Regulation No. 53 (Installation of lighting and light-signalling devices for L₃ vehicles)

Proposal for a draft amendment to Regulation No. 53 (Installation of lighting and light-signalling devices for L_3 category vehicles)

Submitted by the expert from the International Motorcycle Manufacturers Association (IMMA)*

"Annex 7

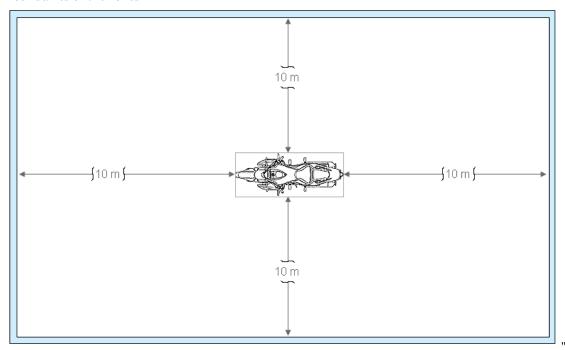
Insert a new Annex 7, to read:

Observing area towards the apparent surface of exterior courtesy lamps

Zones of observation

This drawing shows the zone from one side, the other zones are from the front, the rear and from the other side of the vehicle.

- 6.15.9.2. Approved lamps emitting white light with the exception of main beam headlamps and day time running lamps may be activated as courtesy lamp function. They may also be activated together with the exterior courtesy lamps and the condition of paragraphs 5.10. and 5.11. above may not apply.
- 6.15.9.3. The technical service shall, to the satisfaction of the Type Approval Authority, perform a visual test to verify that there is no direct visibility of the apparent surface of the exterior courtesy lamps, if viewed by an observer moving on the boundary of a zone on a transverse plane 10 m from the front of the vehicle, a transverse plane 10 m from the rear of the vehicle, and two longitudinal planes 10 m from each side of the vehicle; these four planes to extend from 1 m to 3 m above and perpendicular to the ground as shown in Annex 7.
